APPLICATION NUMBER: 12/861,334

PATENT NUMBER: 8420257

Attorney Docket No.	5457-0113PUS1
First Inventor	Sung Jong KIM
Title	CAP ASSEMBLY COMPRISING GASKET PREVENTED FROM SAGGING AND CYLINDRICAL SECONDARY BATTERY COMPRISING THE SAME
Express Mail Label No.

FIG. 1a

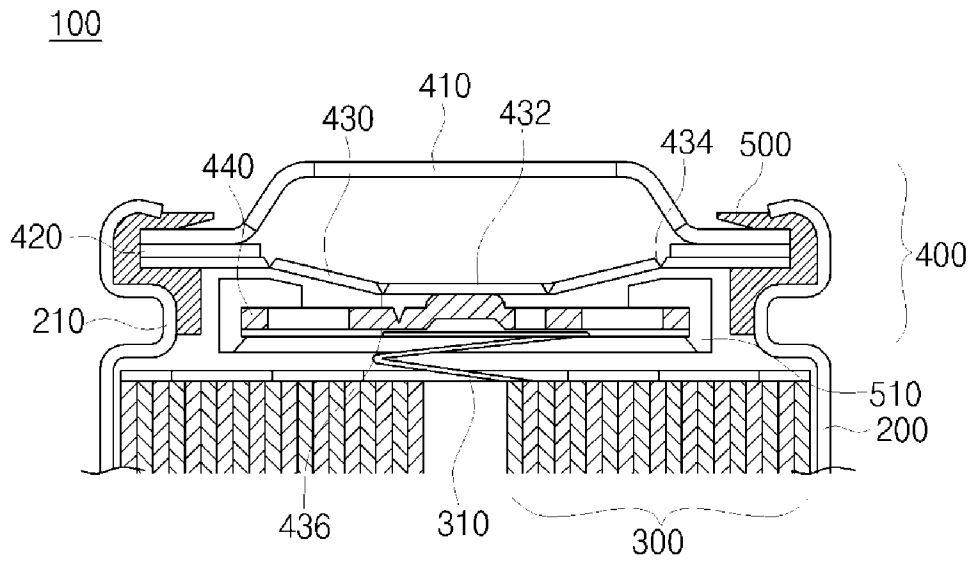
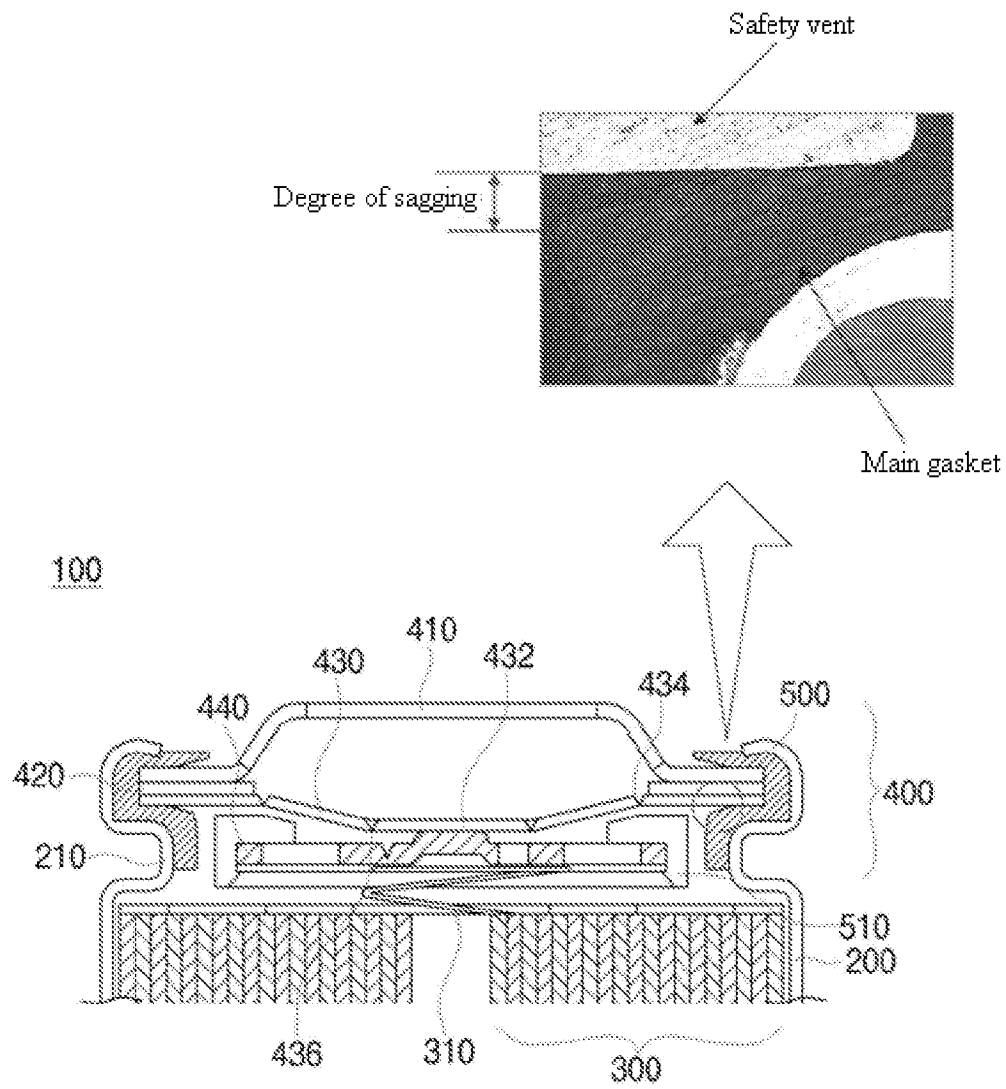
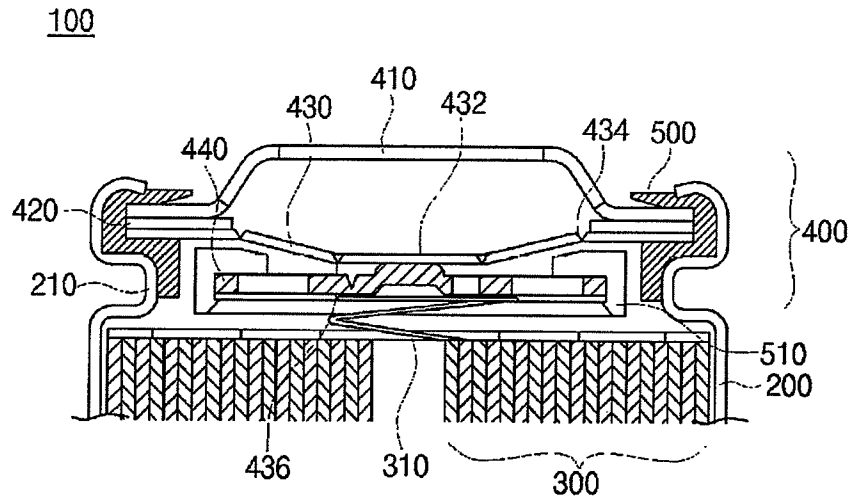
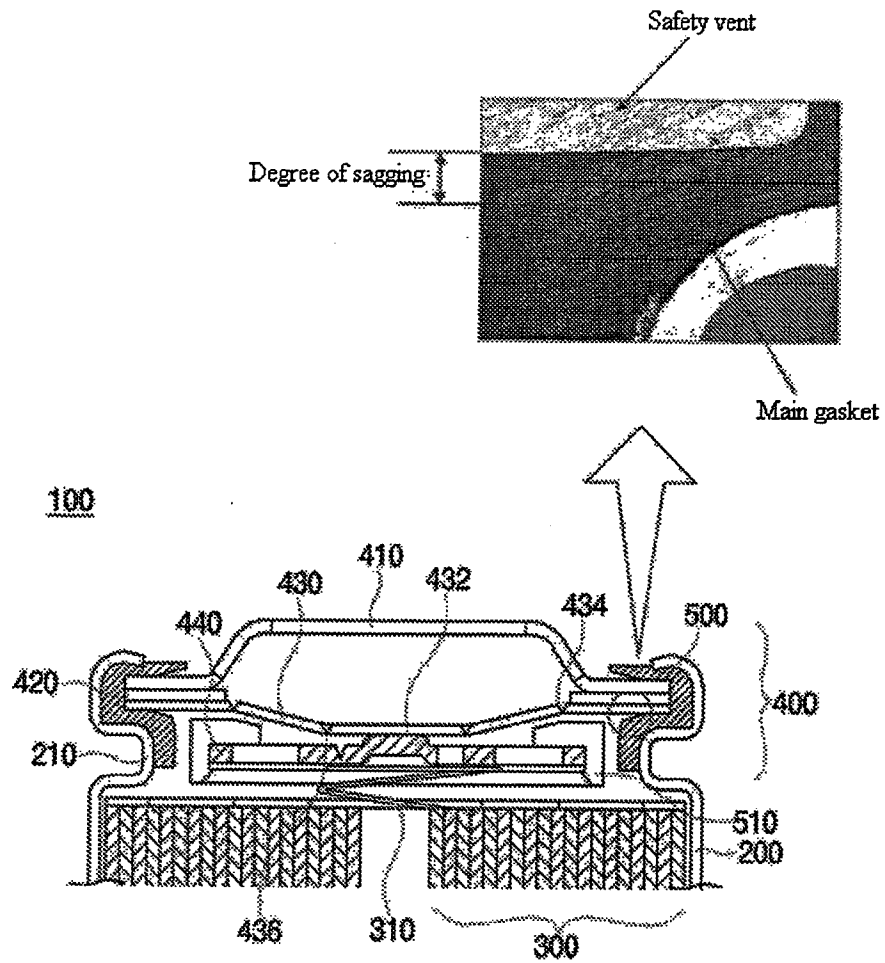
Figures 1a and 1b should be designated by a legend such as --Prior Art-- because only that which is old is illustrated. See MPEP § 608.02(g). Corrected drawings in compliance with 37 CFR 1.121(d) are required in reply to the Office action to avoid abandonment of the application. The replacement sheet(s) should be labeled "Replacement Sheet" in the page header (as per 37 CFR 1.84(c)) so as not to obstruct any portion of the drawing figures. If the changes are not accepted by the examiner, the applicant will be notified and informed of any required corrective action in the next Office action. The objection to the drawings will not be held in abeyance.

In order to overcome this objection, Applicants are concurrently submitting Replacement Drawing Sheets for the Examiner's approval, which address each of the deficiencies pointed out by the Examiner by labeling Figs. 1a and 1b as "Conventional Art," which is consistent with the specification. Accordingly, reconsideration and withdrawal of this objection are respectfully requested.

CONVENTIONAL ART

CONVENTIONAL ART
